**Subject: Bid Package #2**  
Abbott Middle School HVAC Replcmt-DSA 01-119556  
George Hall Elementary School HVAC Replcmt-DSA 01 119523  
Laurel Elementary School HVAC Replcmt DSA 01-119551  
San Mateo - Foster City School District

### **ADDENDUM NO. 3**

San Mateo-Foster City School District  
HVAC Replacement Scope,  
Abbott MS DSA 01-119556  
George Hall ES DSA 01-119523  
Laurel ES DSA 01-119551

SHEET # **AD3-  
A1.02**

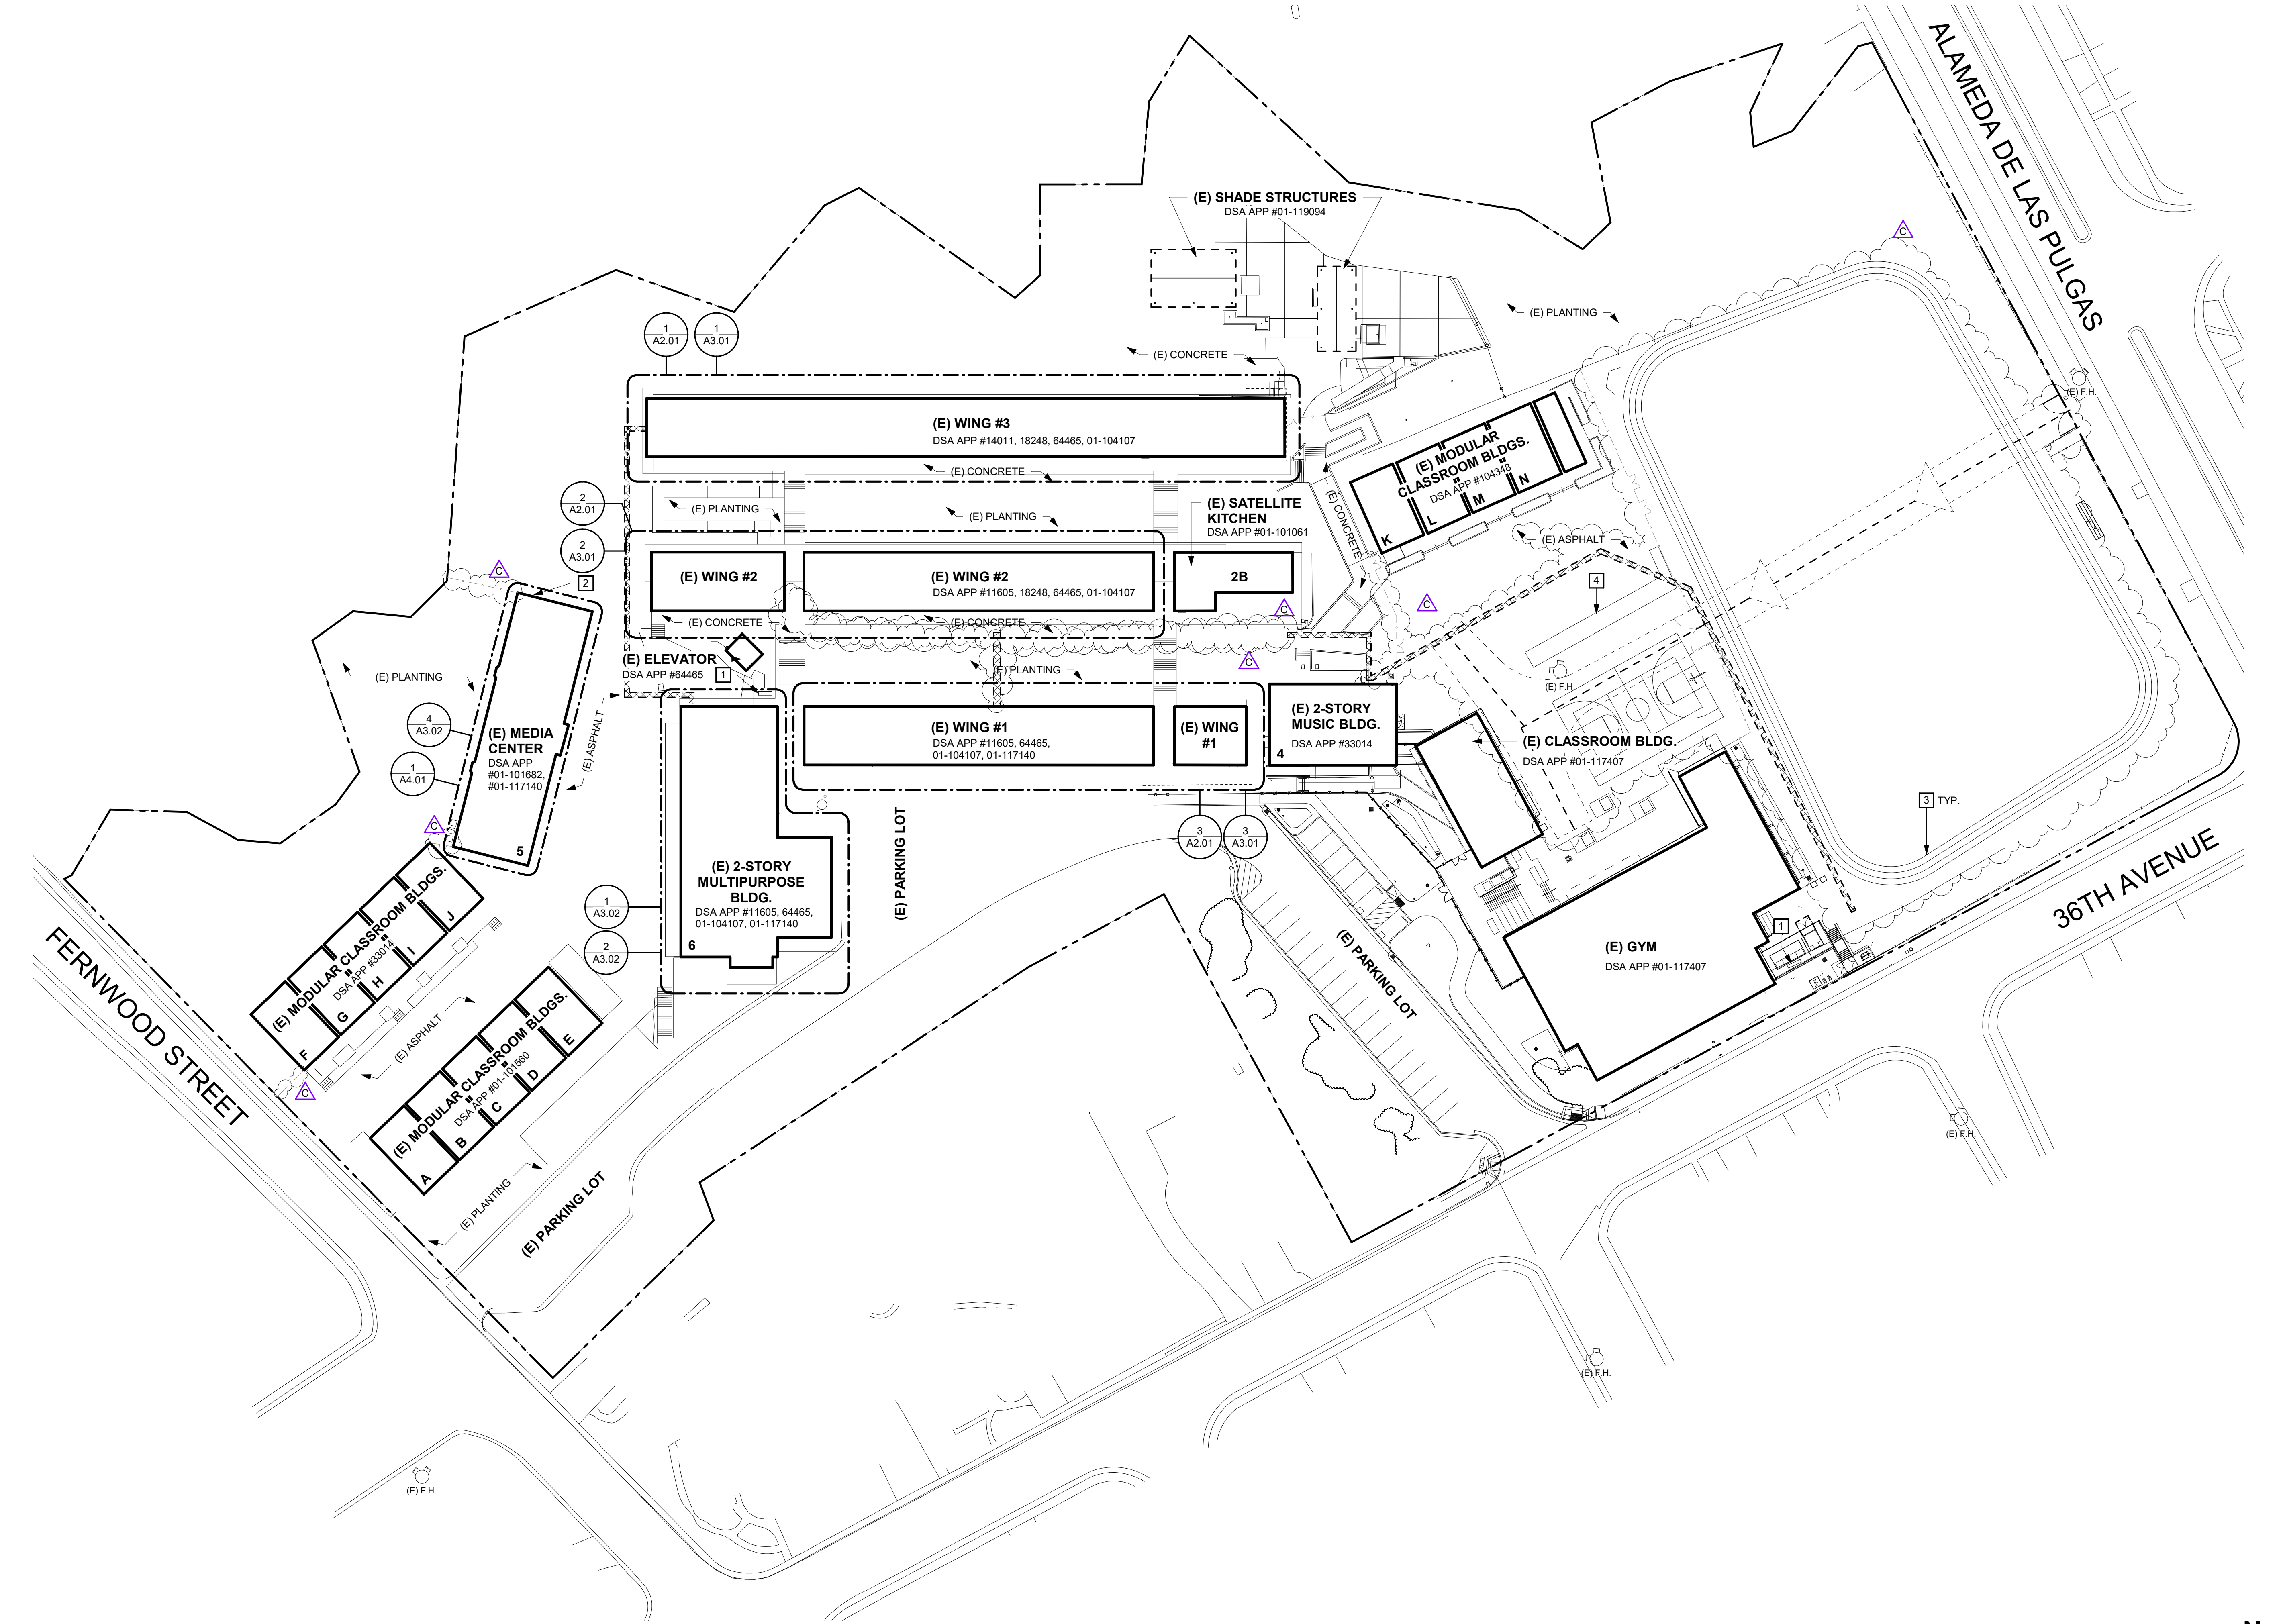
ITEM NO. 3.10:      DRAWING SHEET A1.02 – SITE PLAN

Revise: Existing striping at existing asphalt paving per attached AD3-A1.02.

Revise: Electrical trench routing per attached AD3-A1.02.

Add: Existing chain link fencing locations in plan per attached AD3-A1.02.

Add: Fire department access route in plan per attached AD3-A1.02.

Add: (E) Chain-link fence & (E) Fire Department Access graphics to Graphic Key per attached AD3-A1.02.

Add: Site Plan Keynotes #3 & #4 and associated tags in plan per attached AD3-A1.02.

DATE	12/22/2021
JOB #	2021005.06
SHEET #	AD-3 A3.01

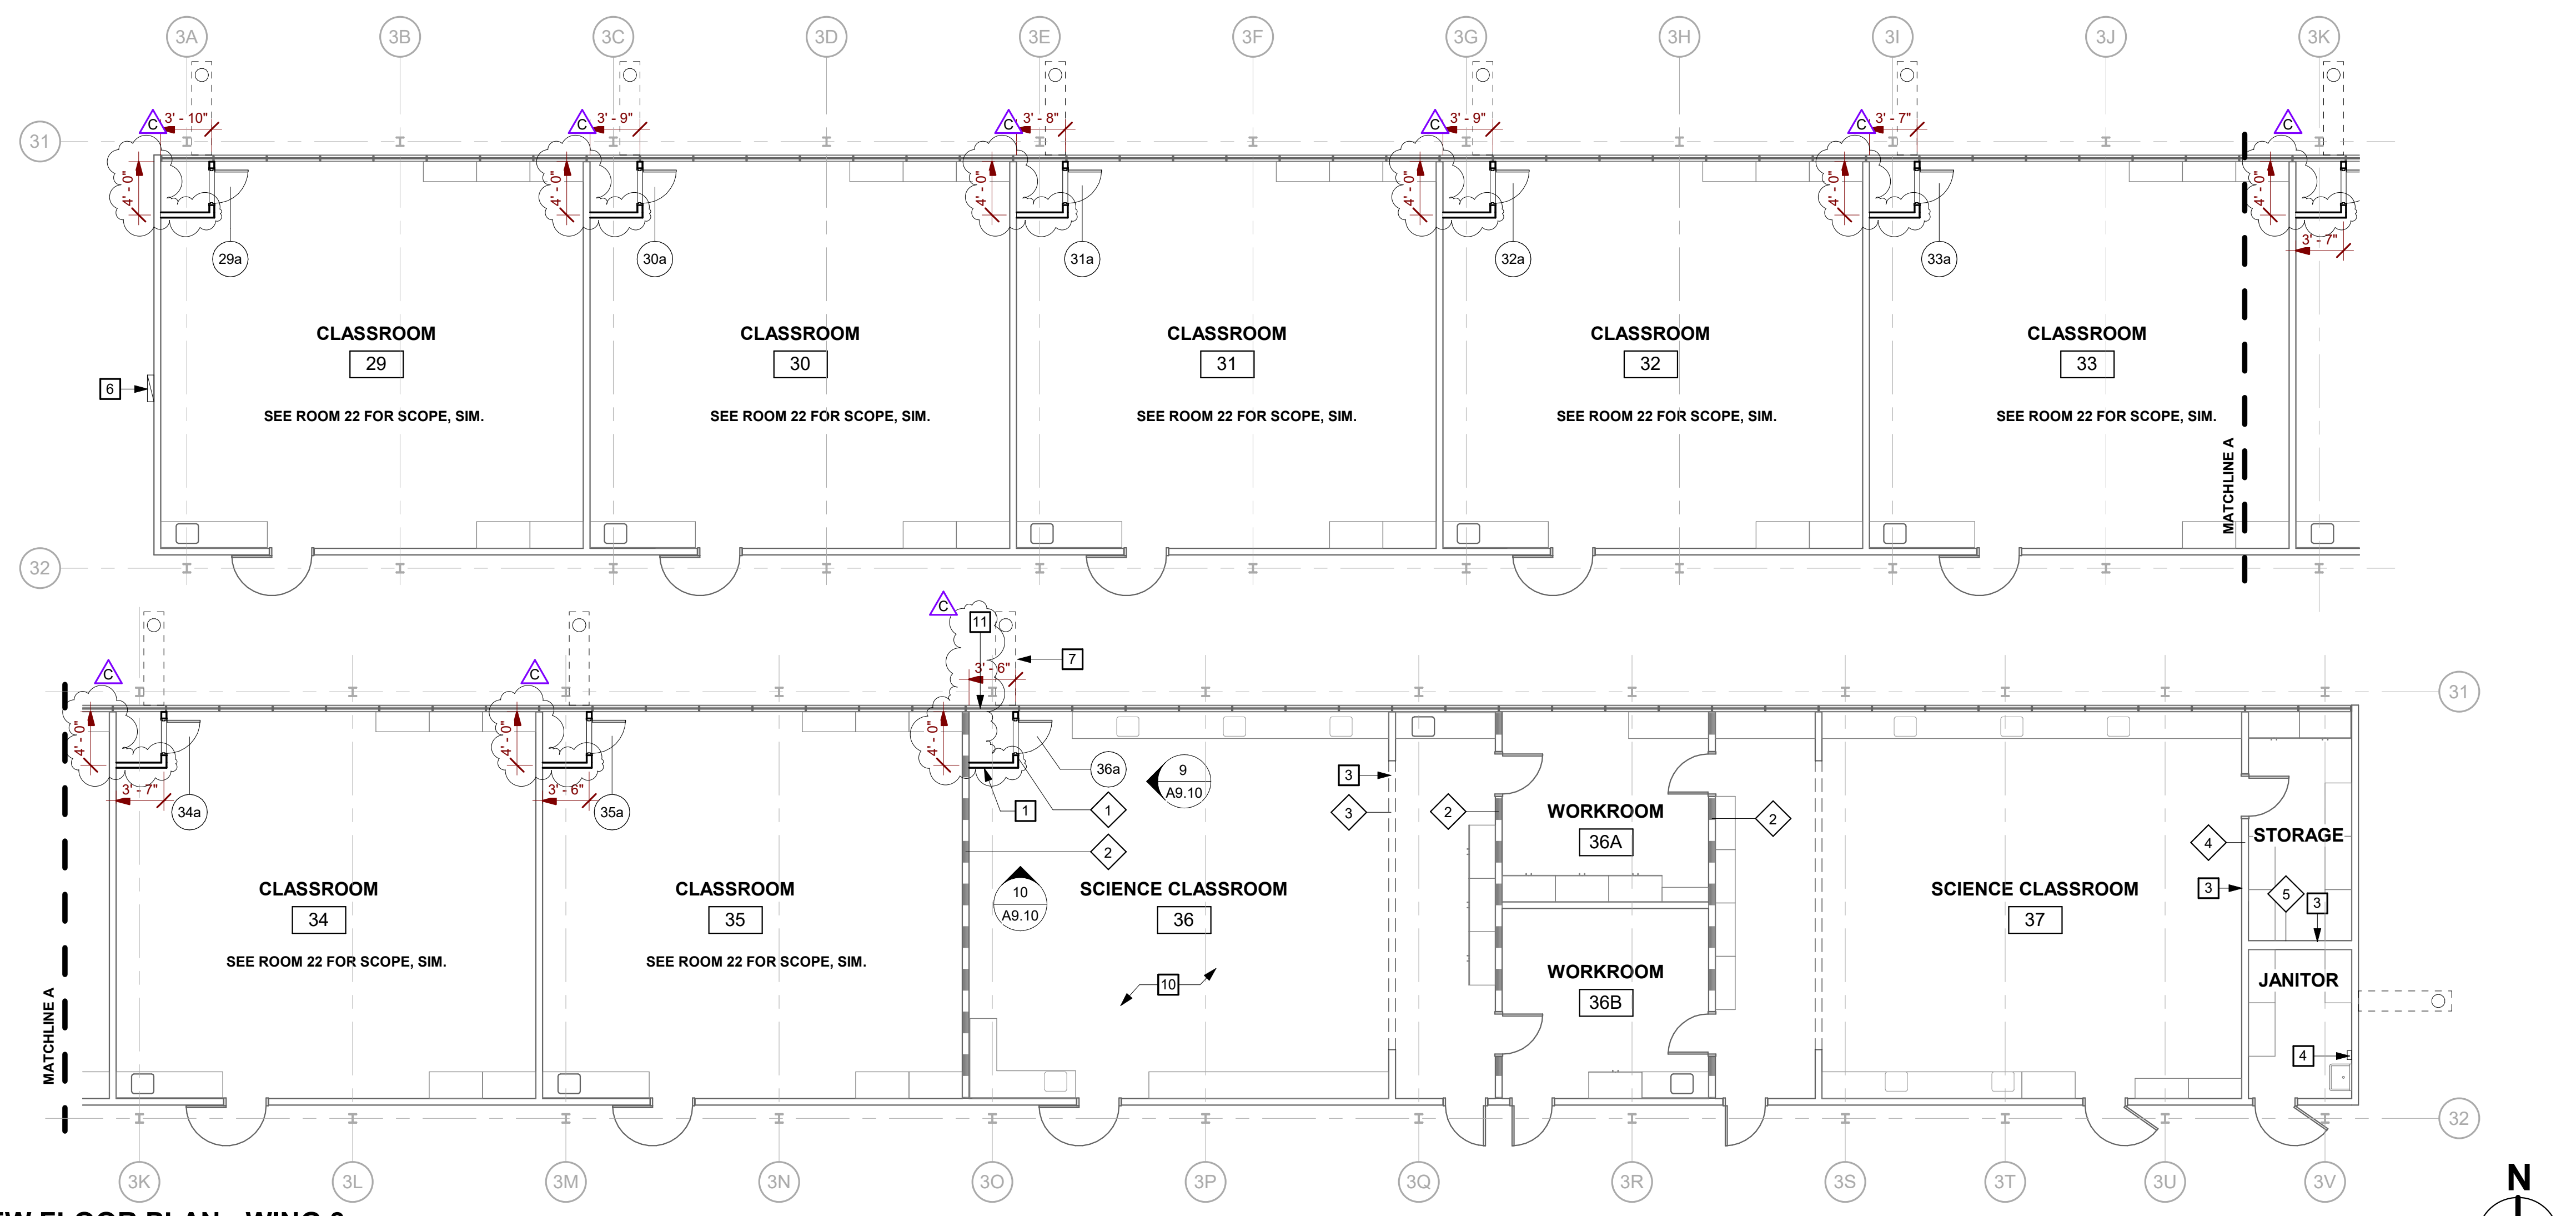
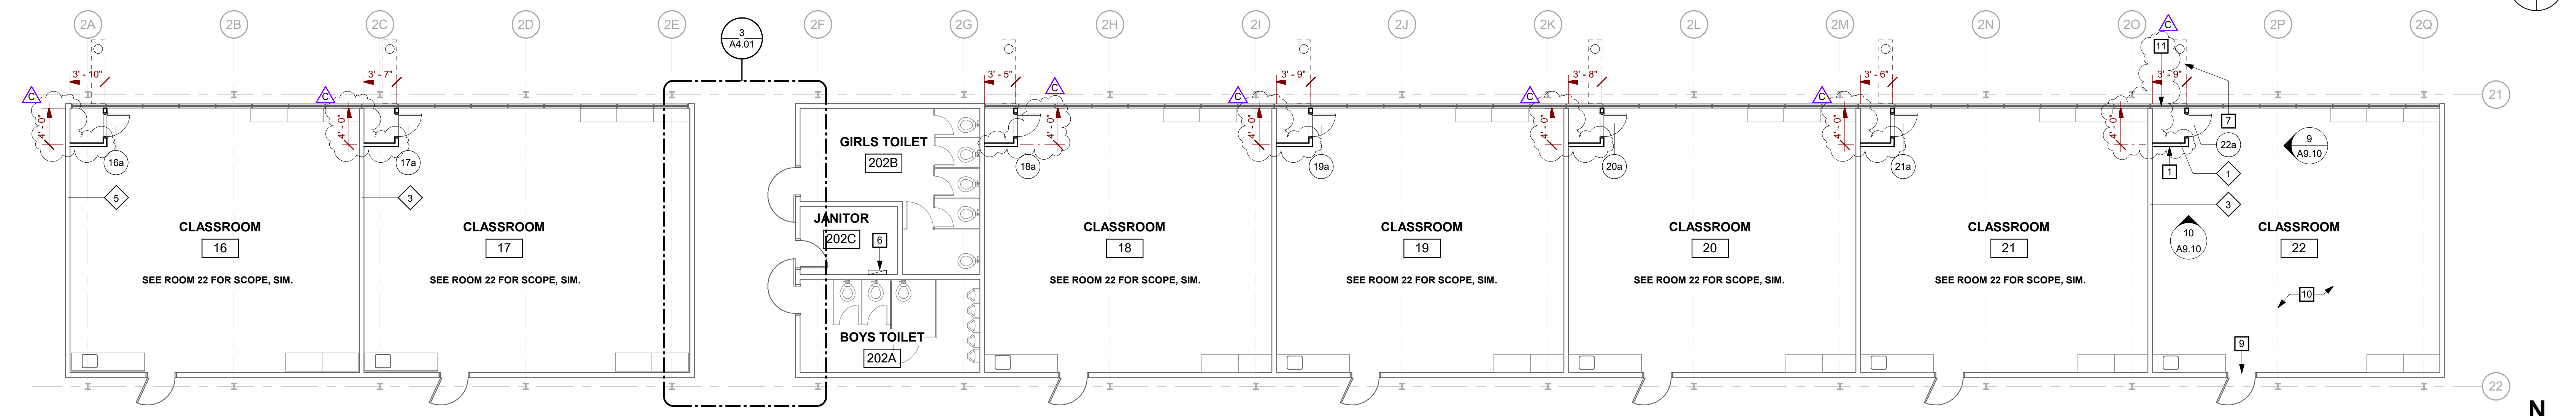
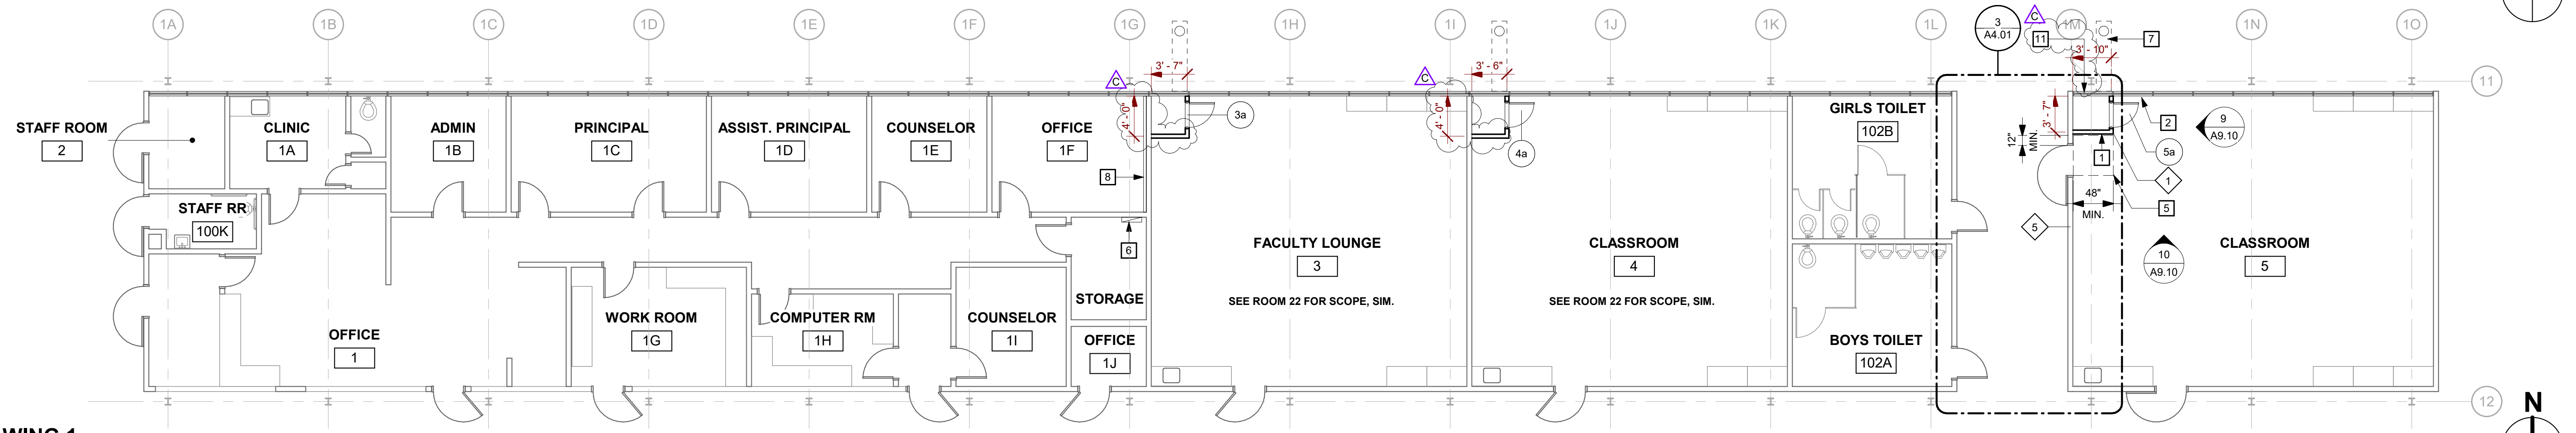
**ITEM NO. 3.12: DRAWING SHEET A3.01 – NEW FLOOR PLANS – WINGS 1, 2 & 3**

Add: General Sheet Note #G per attached AD3-A3.01

Add: Floor Plan Keynote #11 and related tags on the new floor plans per attached AD3-A3.01.

Revise: Floor Plan Keynote #9 per attached AD3-A3.01

Revise: Framing dimensions per attached AD3-A3.01
